## PROPOSAL FOR A CORRIGENDUM TO GLOBAL TECHNICAL REGULATION No. 2

Note: The text reproduced below was prepared by WMTC in order to correct gearshift-related prescriptions in the WMTC GTR (amended text is shown in **bold and underlined**)

Figure A13-1: Example of a gearshift sketch

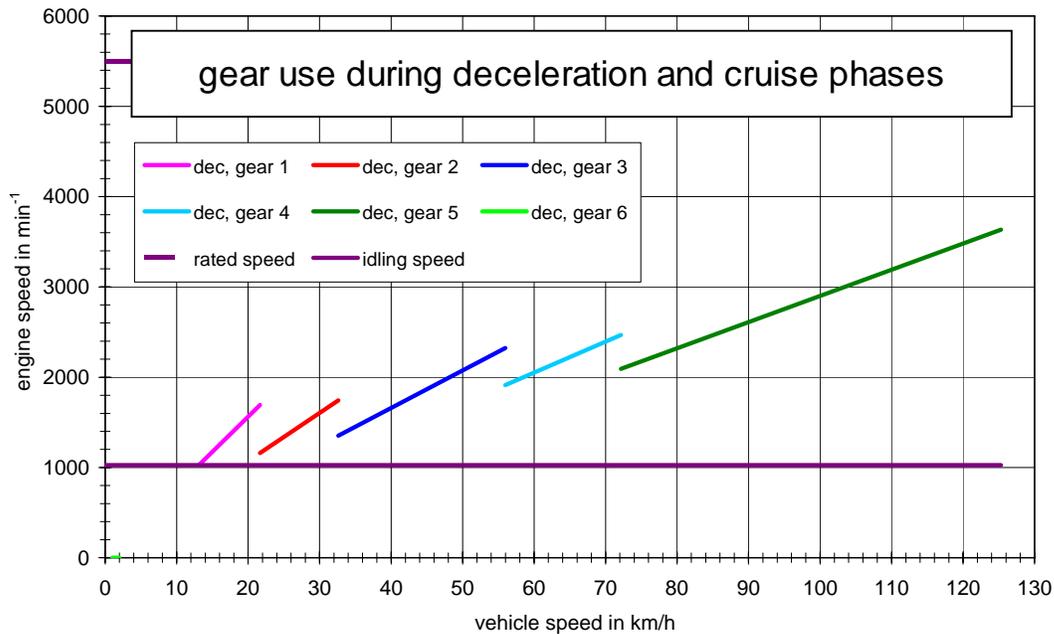
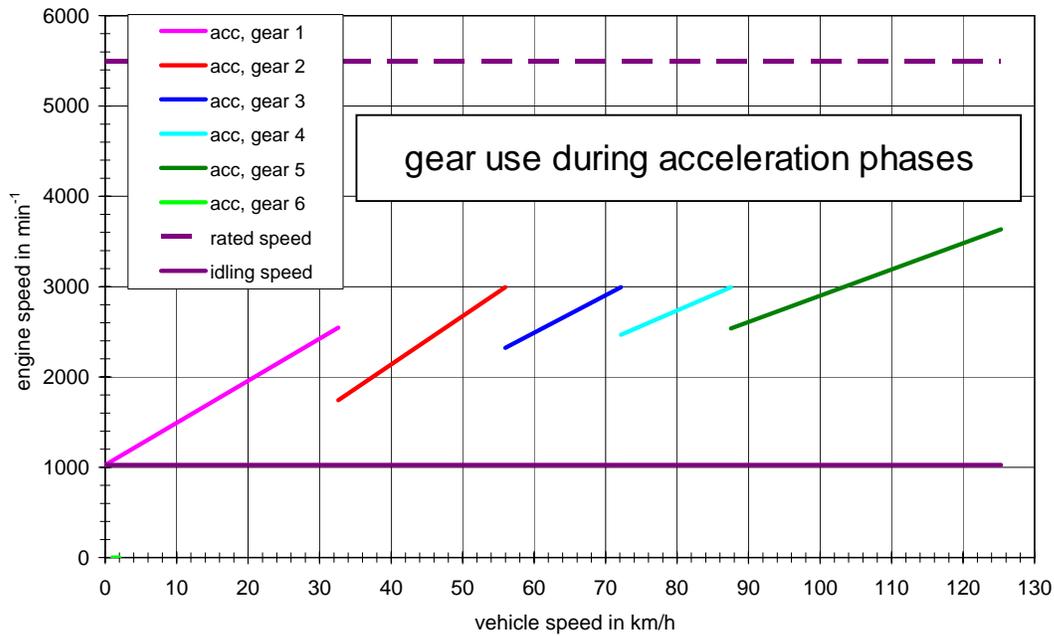
**In case of gradually increase of vehicle speed during cruise phases upshift speeds ( $v_{1 \rightarrow 2}$ ,  $v_{2 \rightarrow 3}$  and  $v_{i \rightarrow i+1}$ ) in km/h may be calculated using the following equations:**
